UNITED STATES PATENT AND TRADEMARK OFFICE

APPLICATION NO.	FILING DATE	FIRST NAMED INVENTOR	ATTORNEY DOCKET NO.	CONFIRMATION NO.
10/826,046	04/16/2004	Steven S. Homer	200315743-1	9457
22879	7590	11/16/2006		EXAMINER
				PAPE, ZACHARY
			ART UNIT	PAPER NUMBER
			2835

Office Action Summary	Application No.	Applicant(s)	
	10/826,046	HOMER, STEVEN S.	
	Examiner	Art Unit	
	Zachary M. Pape	2835

DETAILED ACTION

Fig 1

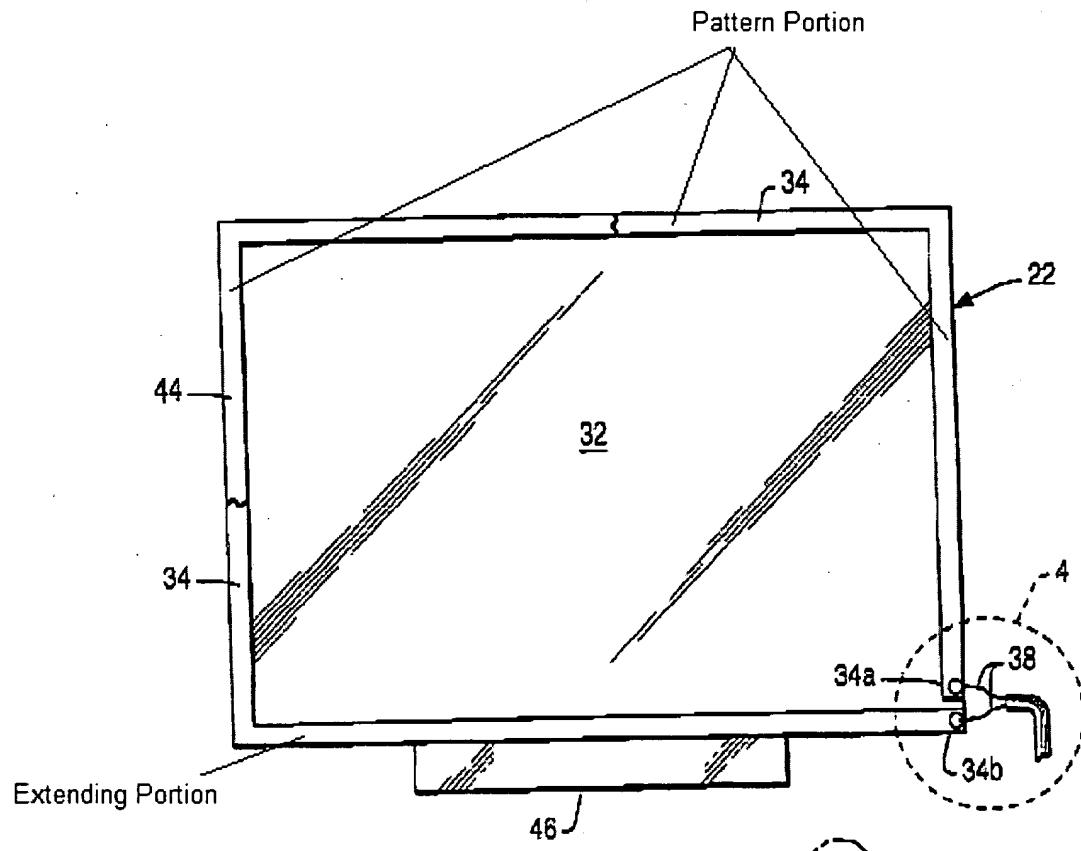
With respect to claim 18, Detwiler further teaches providing a screen (32) having a pattern antenna portion disposed on the interior surface of thereof (See Fig 3, see also POA Fig 1 above).

With respect to claim 19, Detwiler further teaches a screen having an extension portion extending from the pattern antenna portion to a screen connector (See POA Fig 1 above).

With respect to claim 23, Detwiler further teaches that the antenna (34) comprises a pattern portion (See Present office action Fig 1 below).

With respect to claim 24, Detwiler further teaches that the antenna comprises an extending portion (See POA Fig 1 above) extending from the pattern portion to a screen member connector (46).
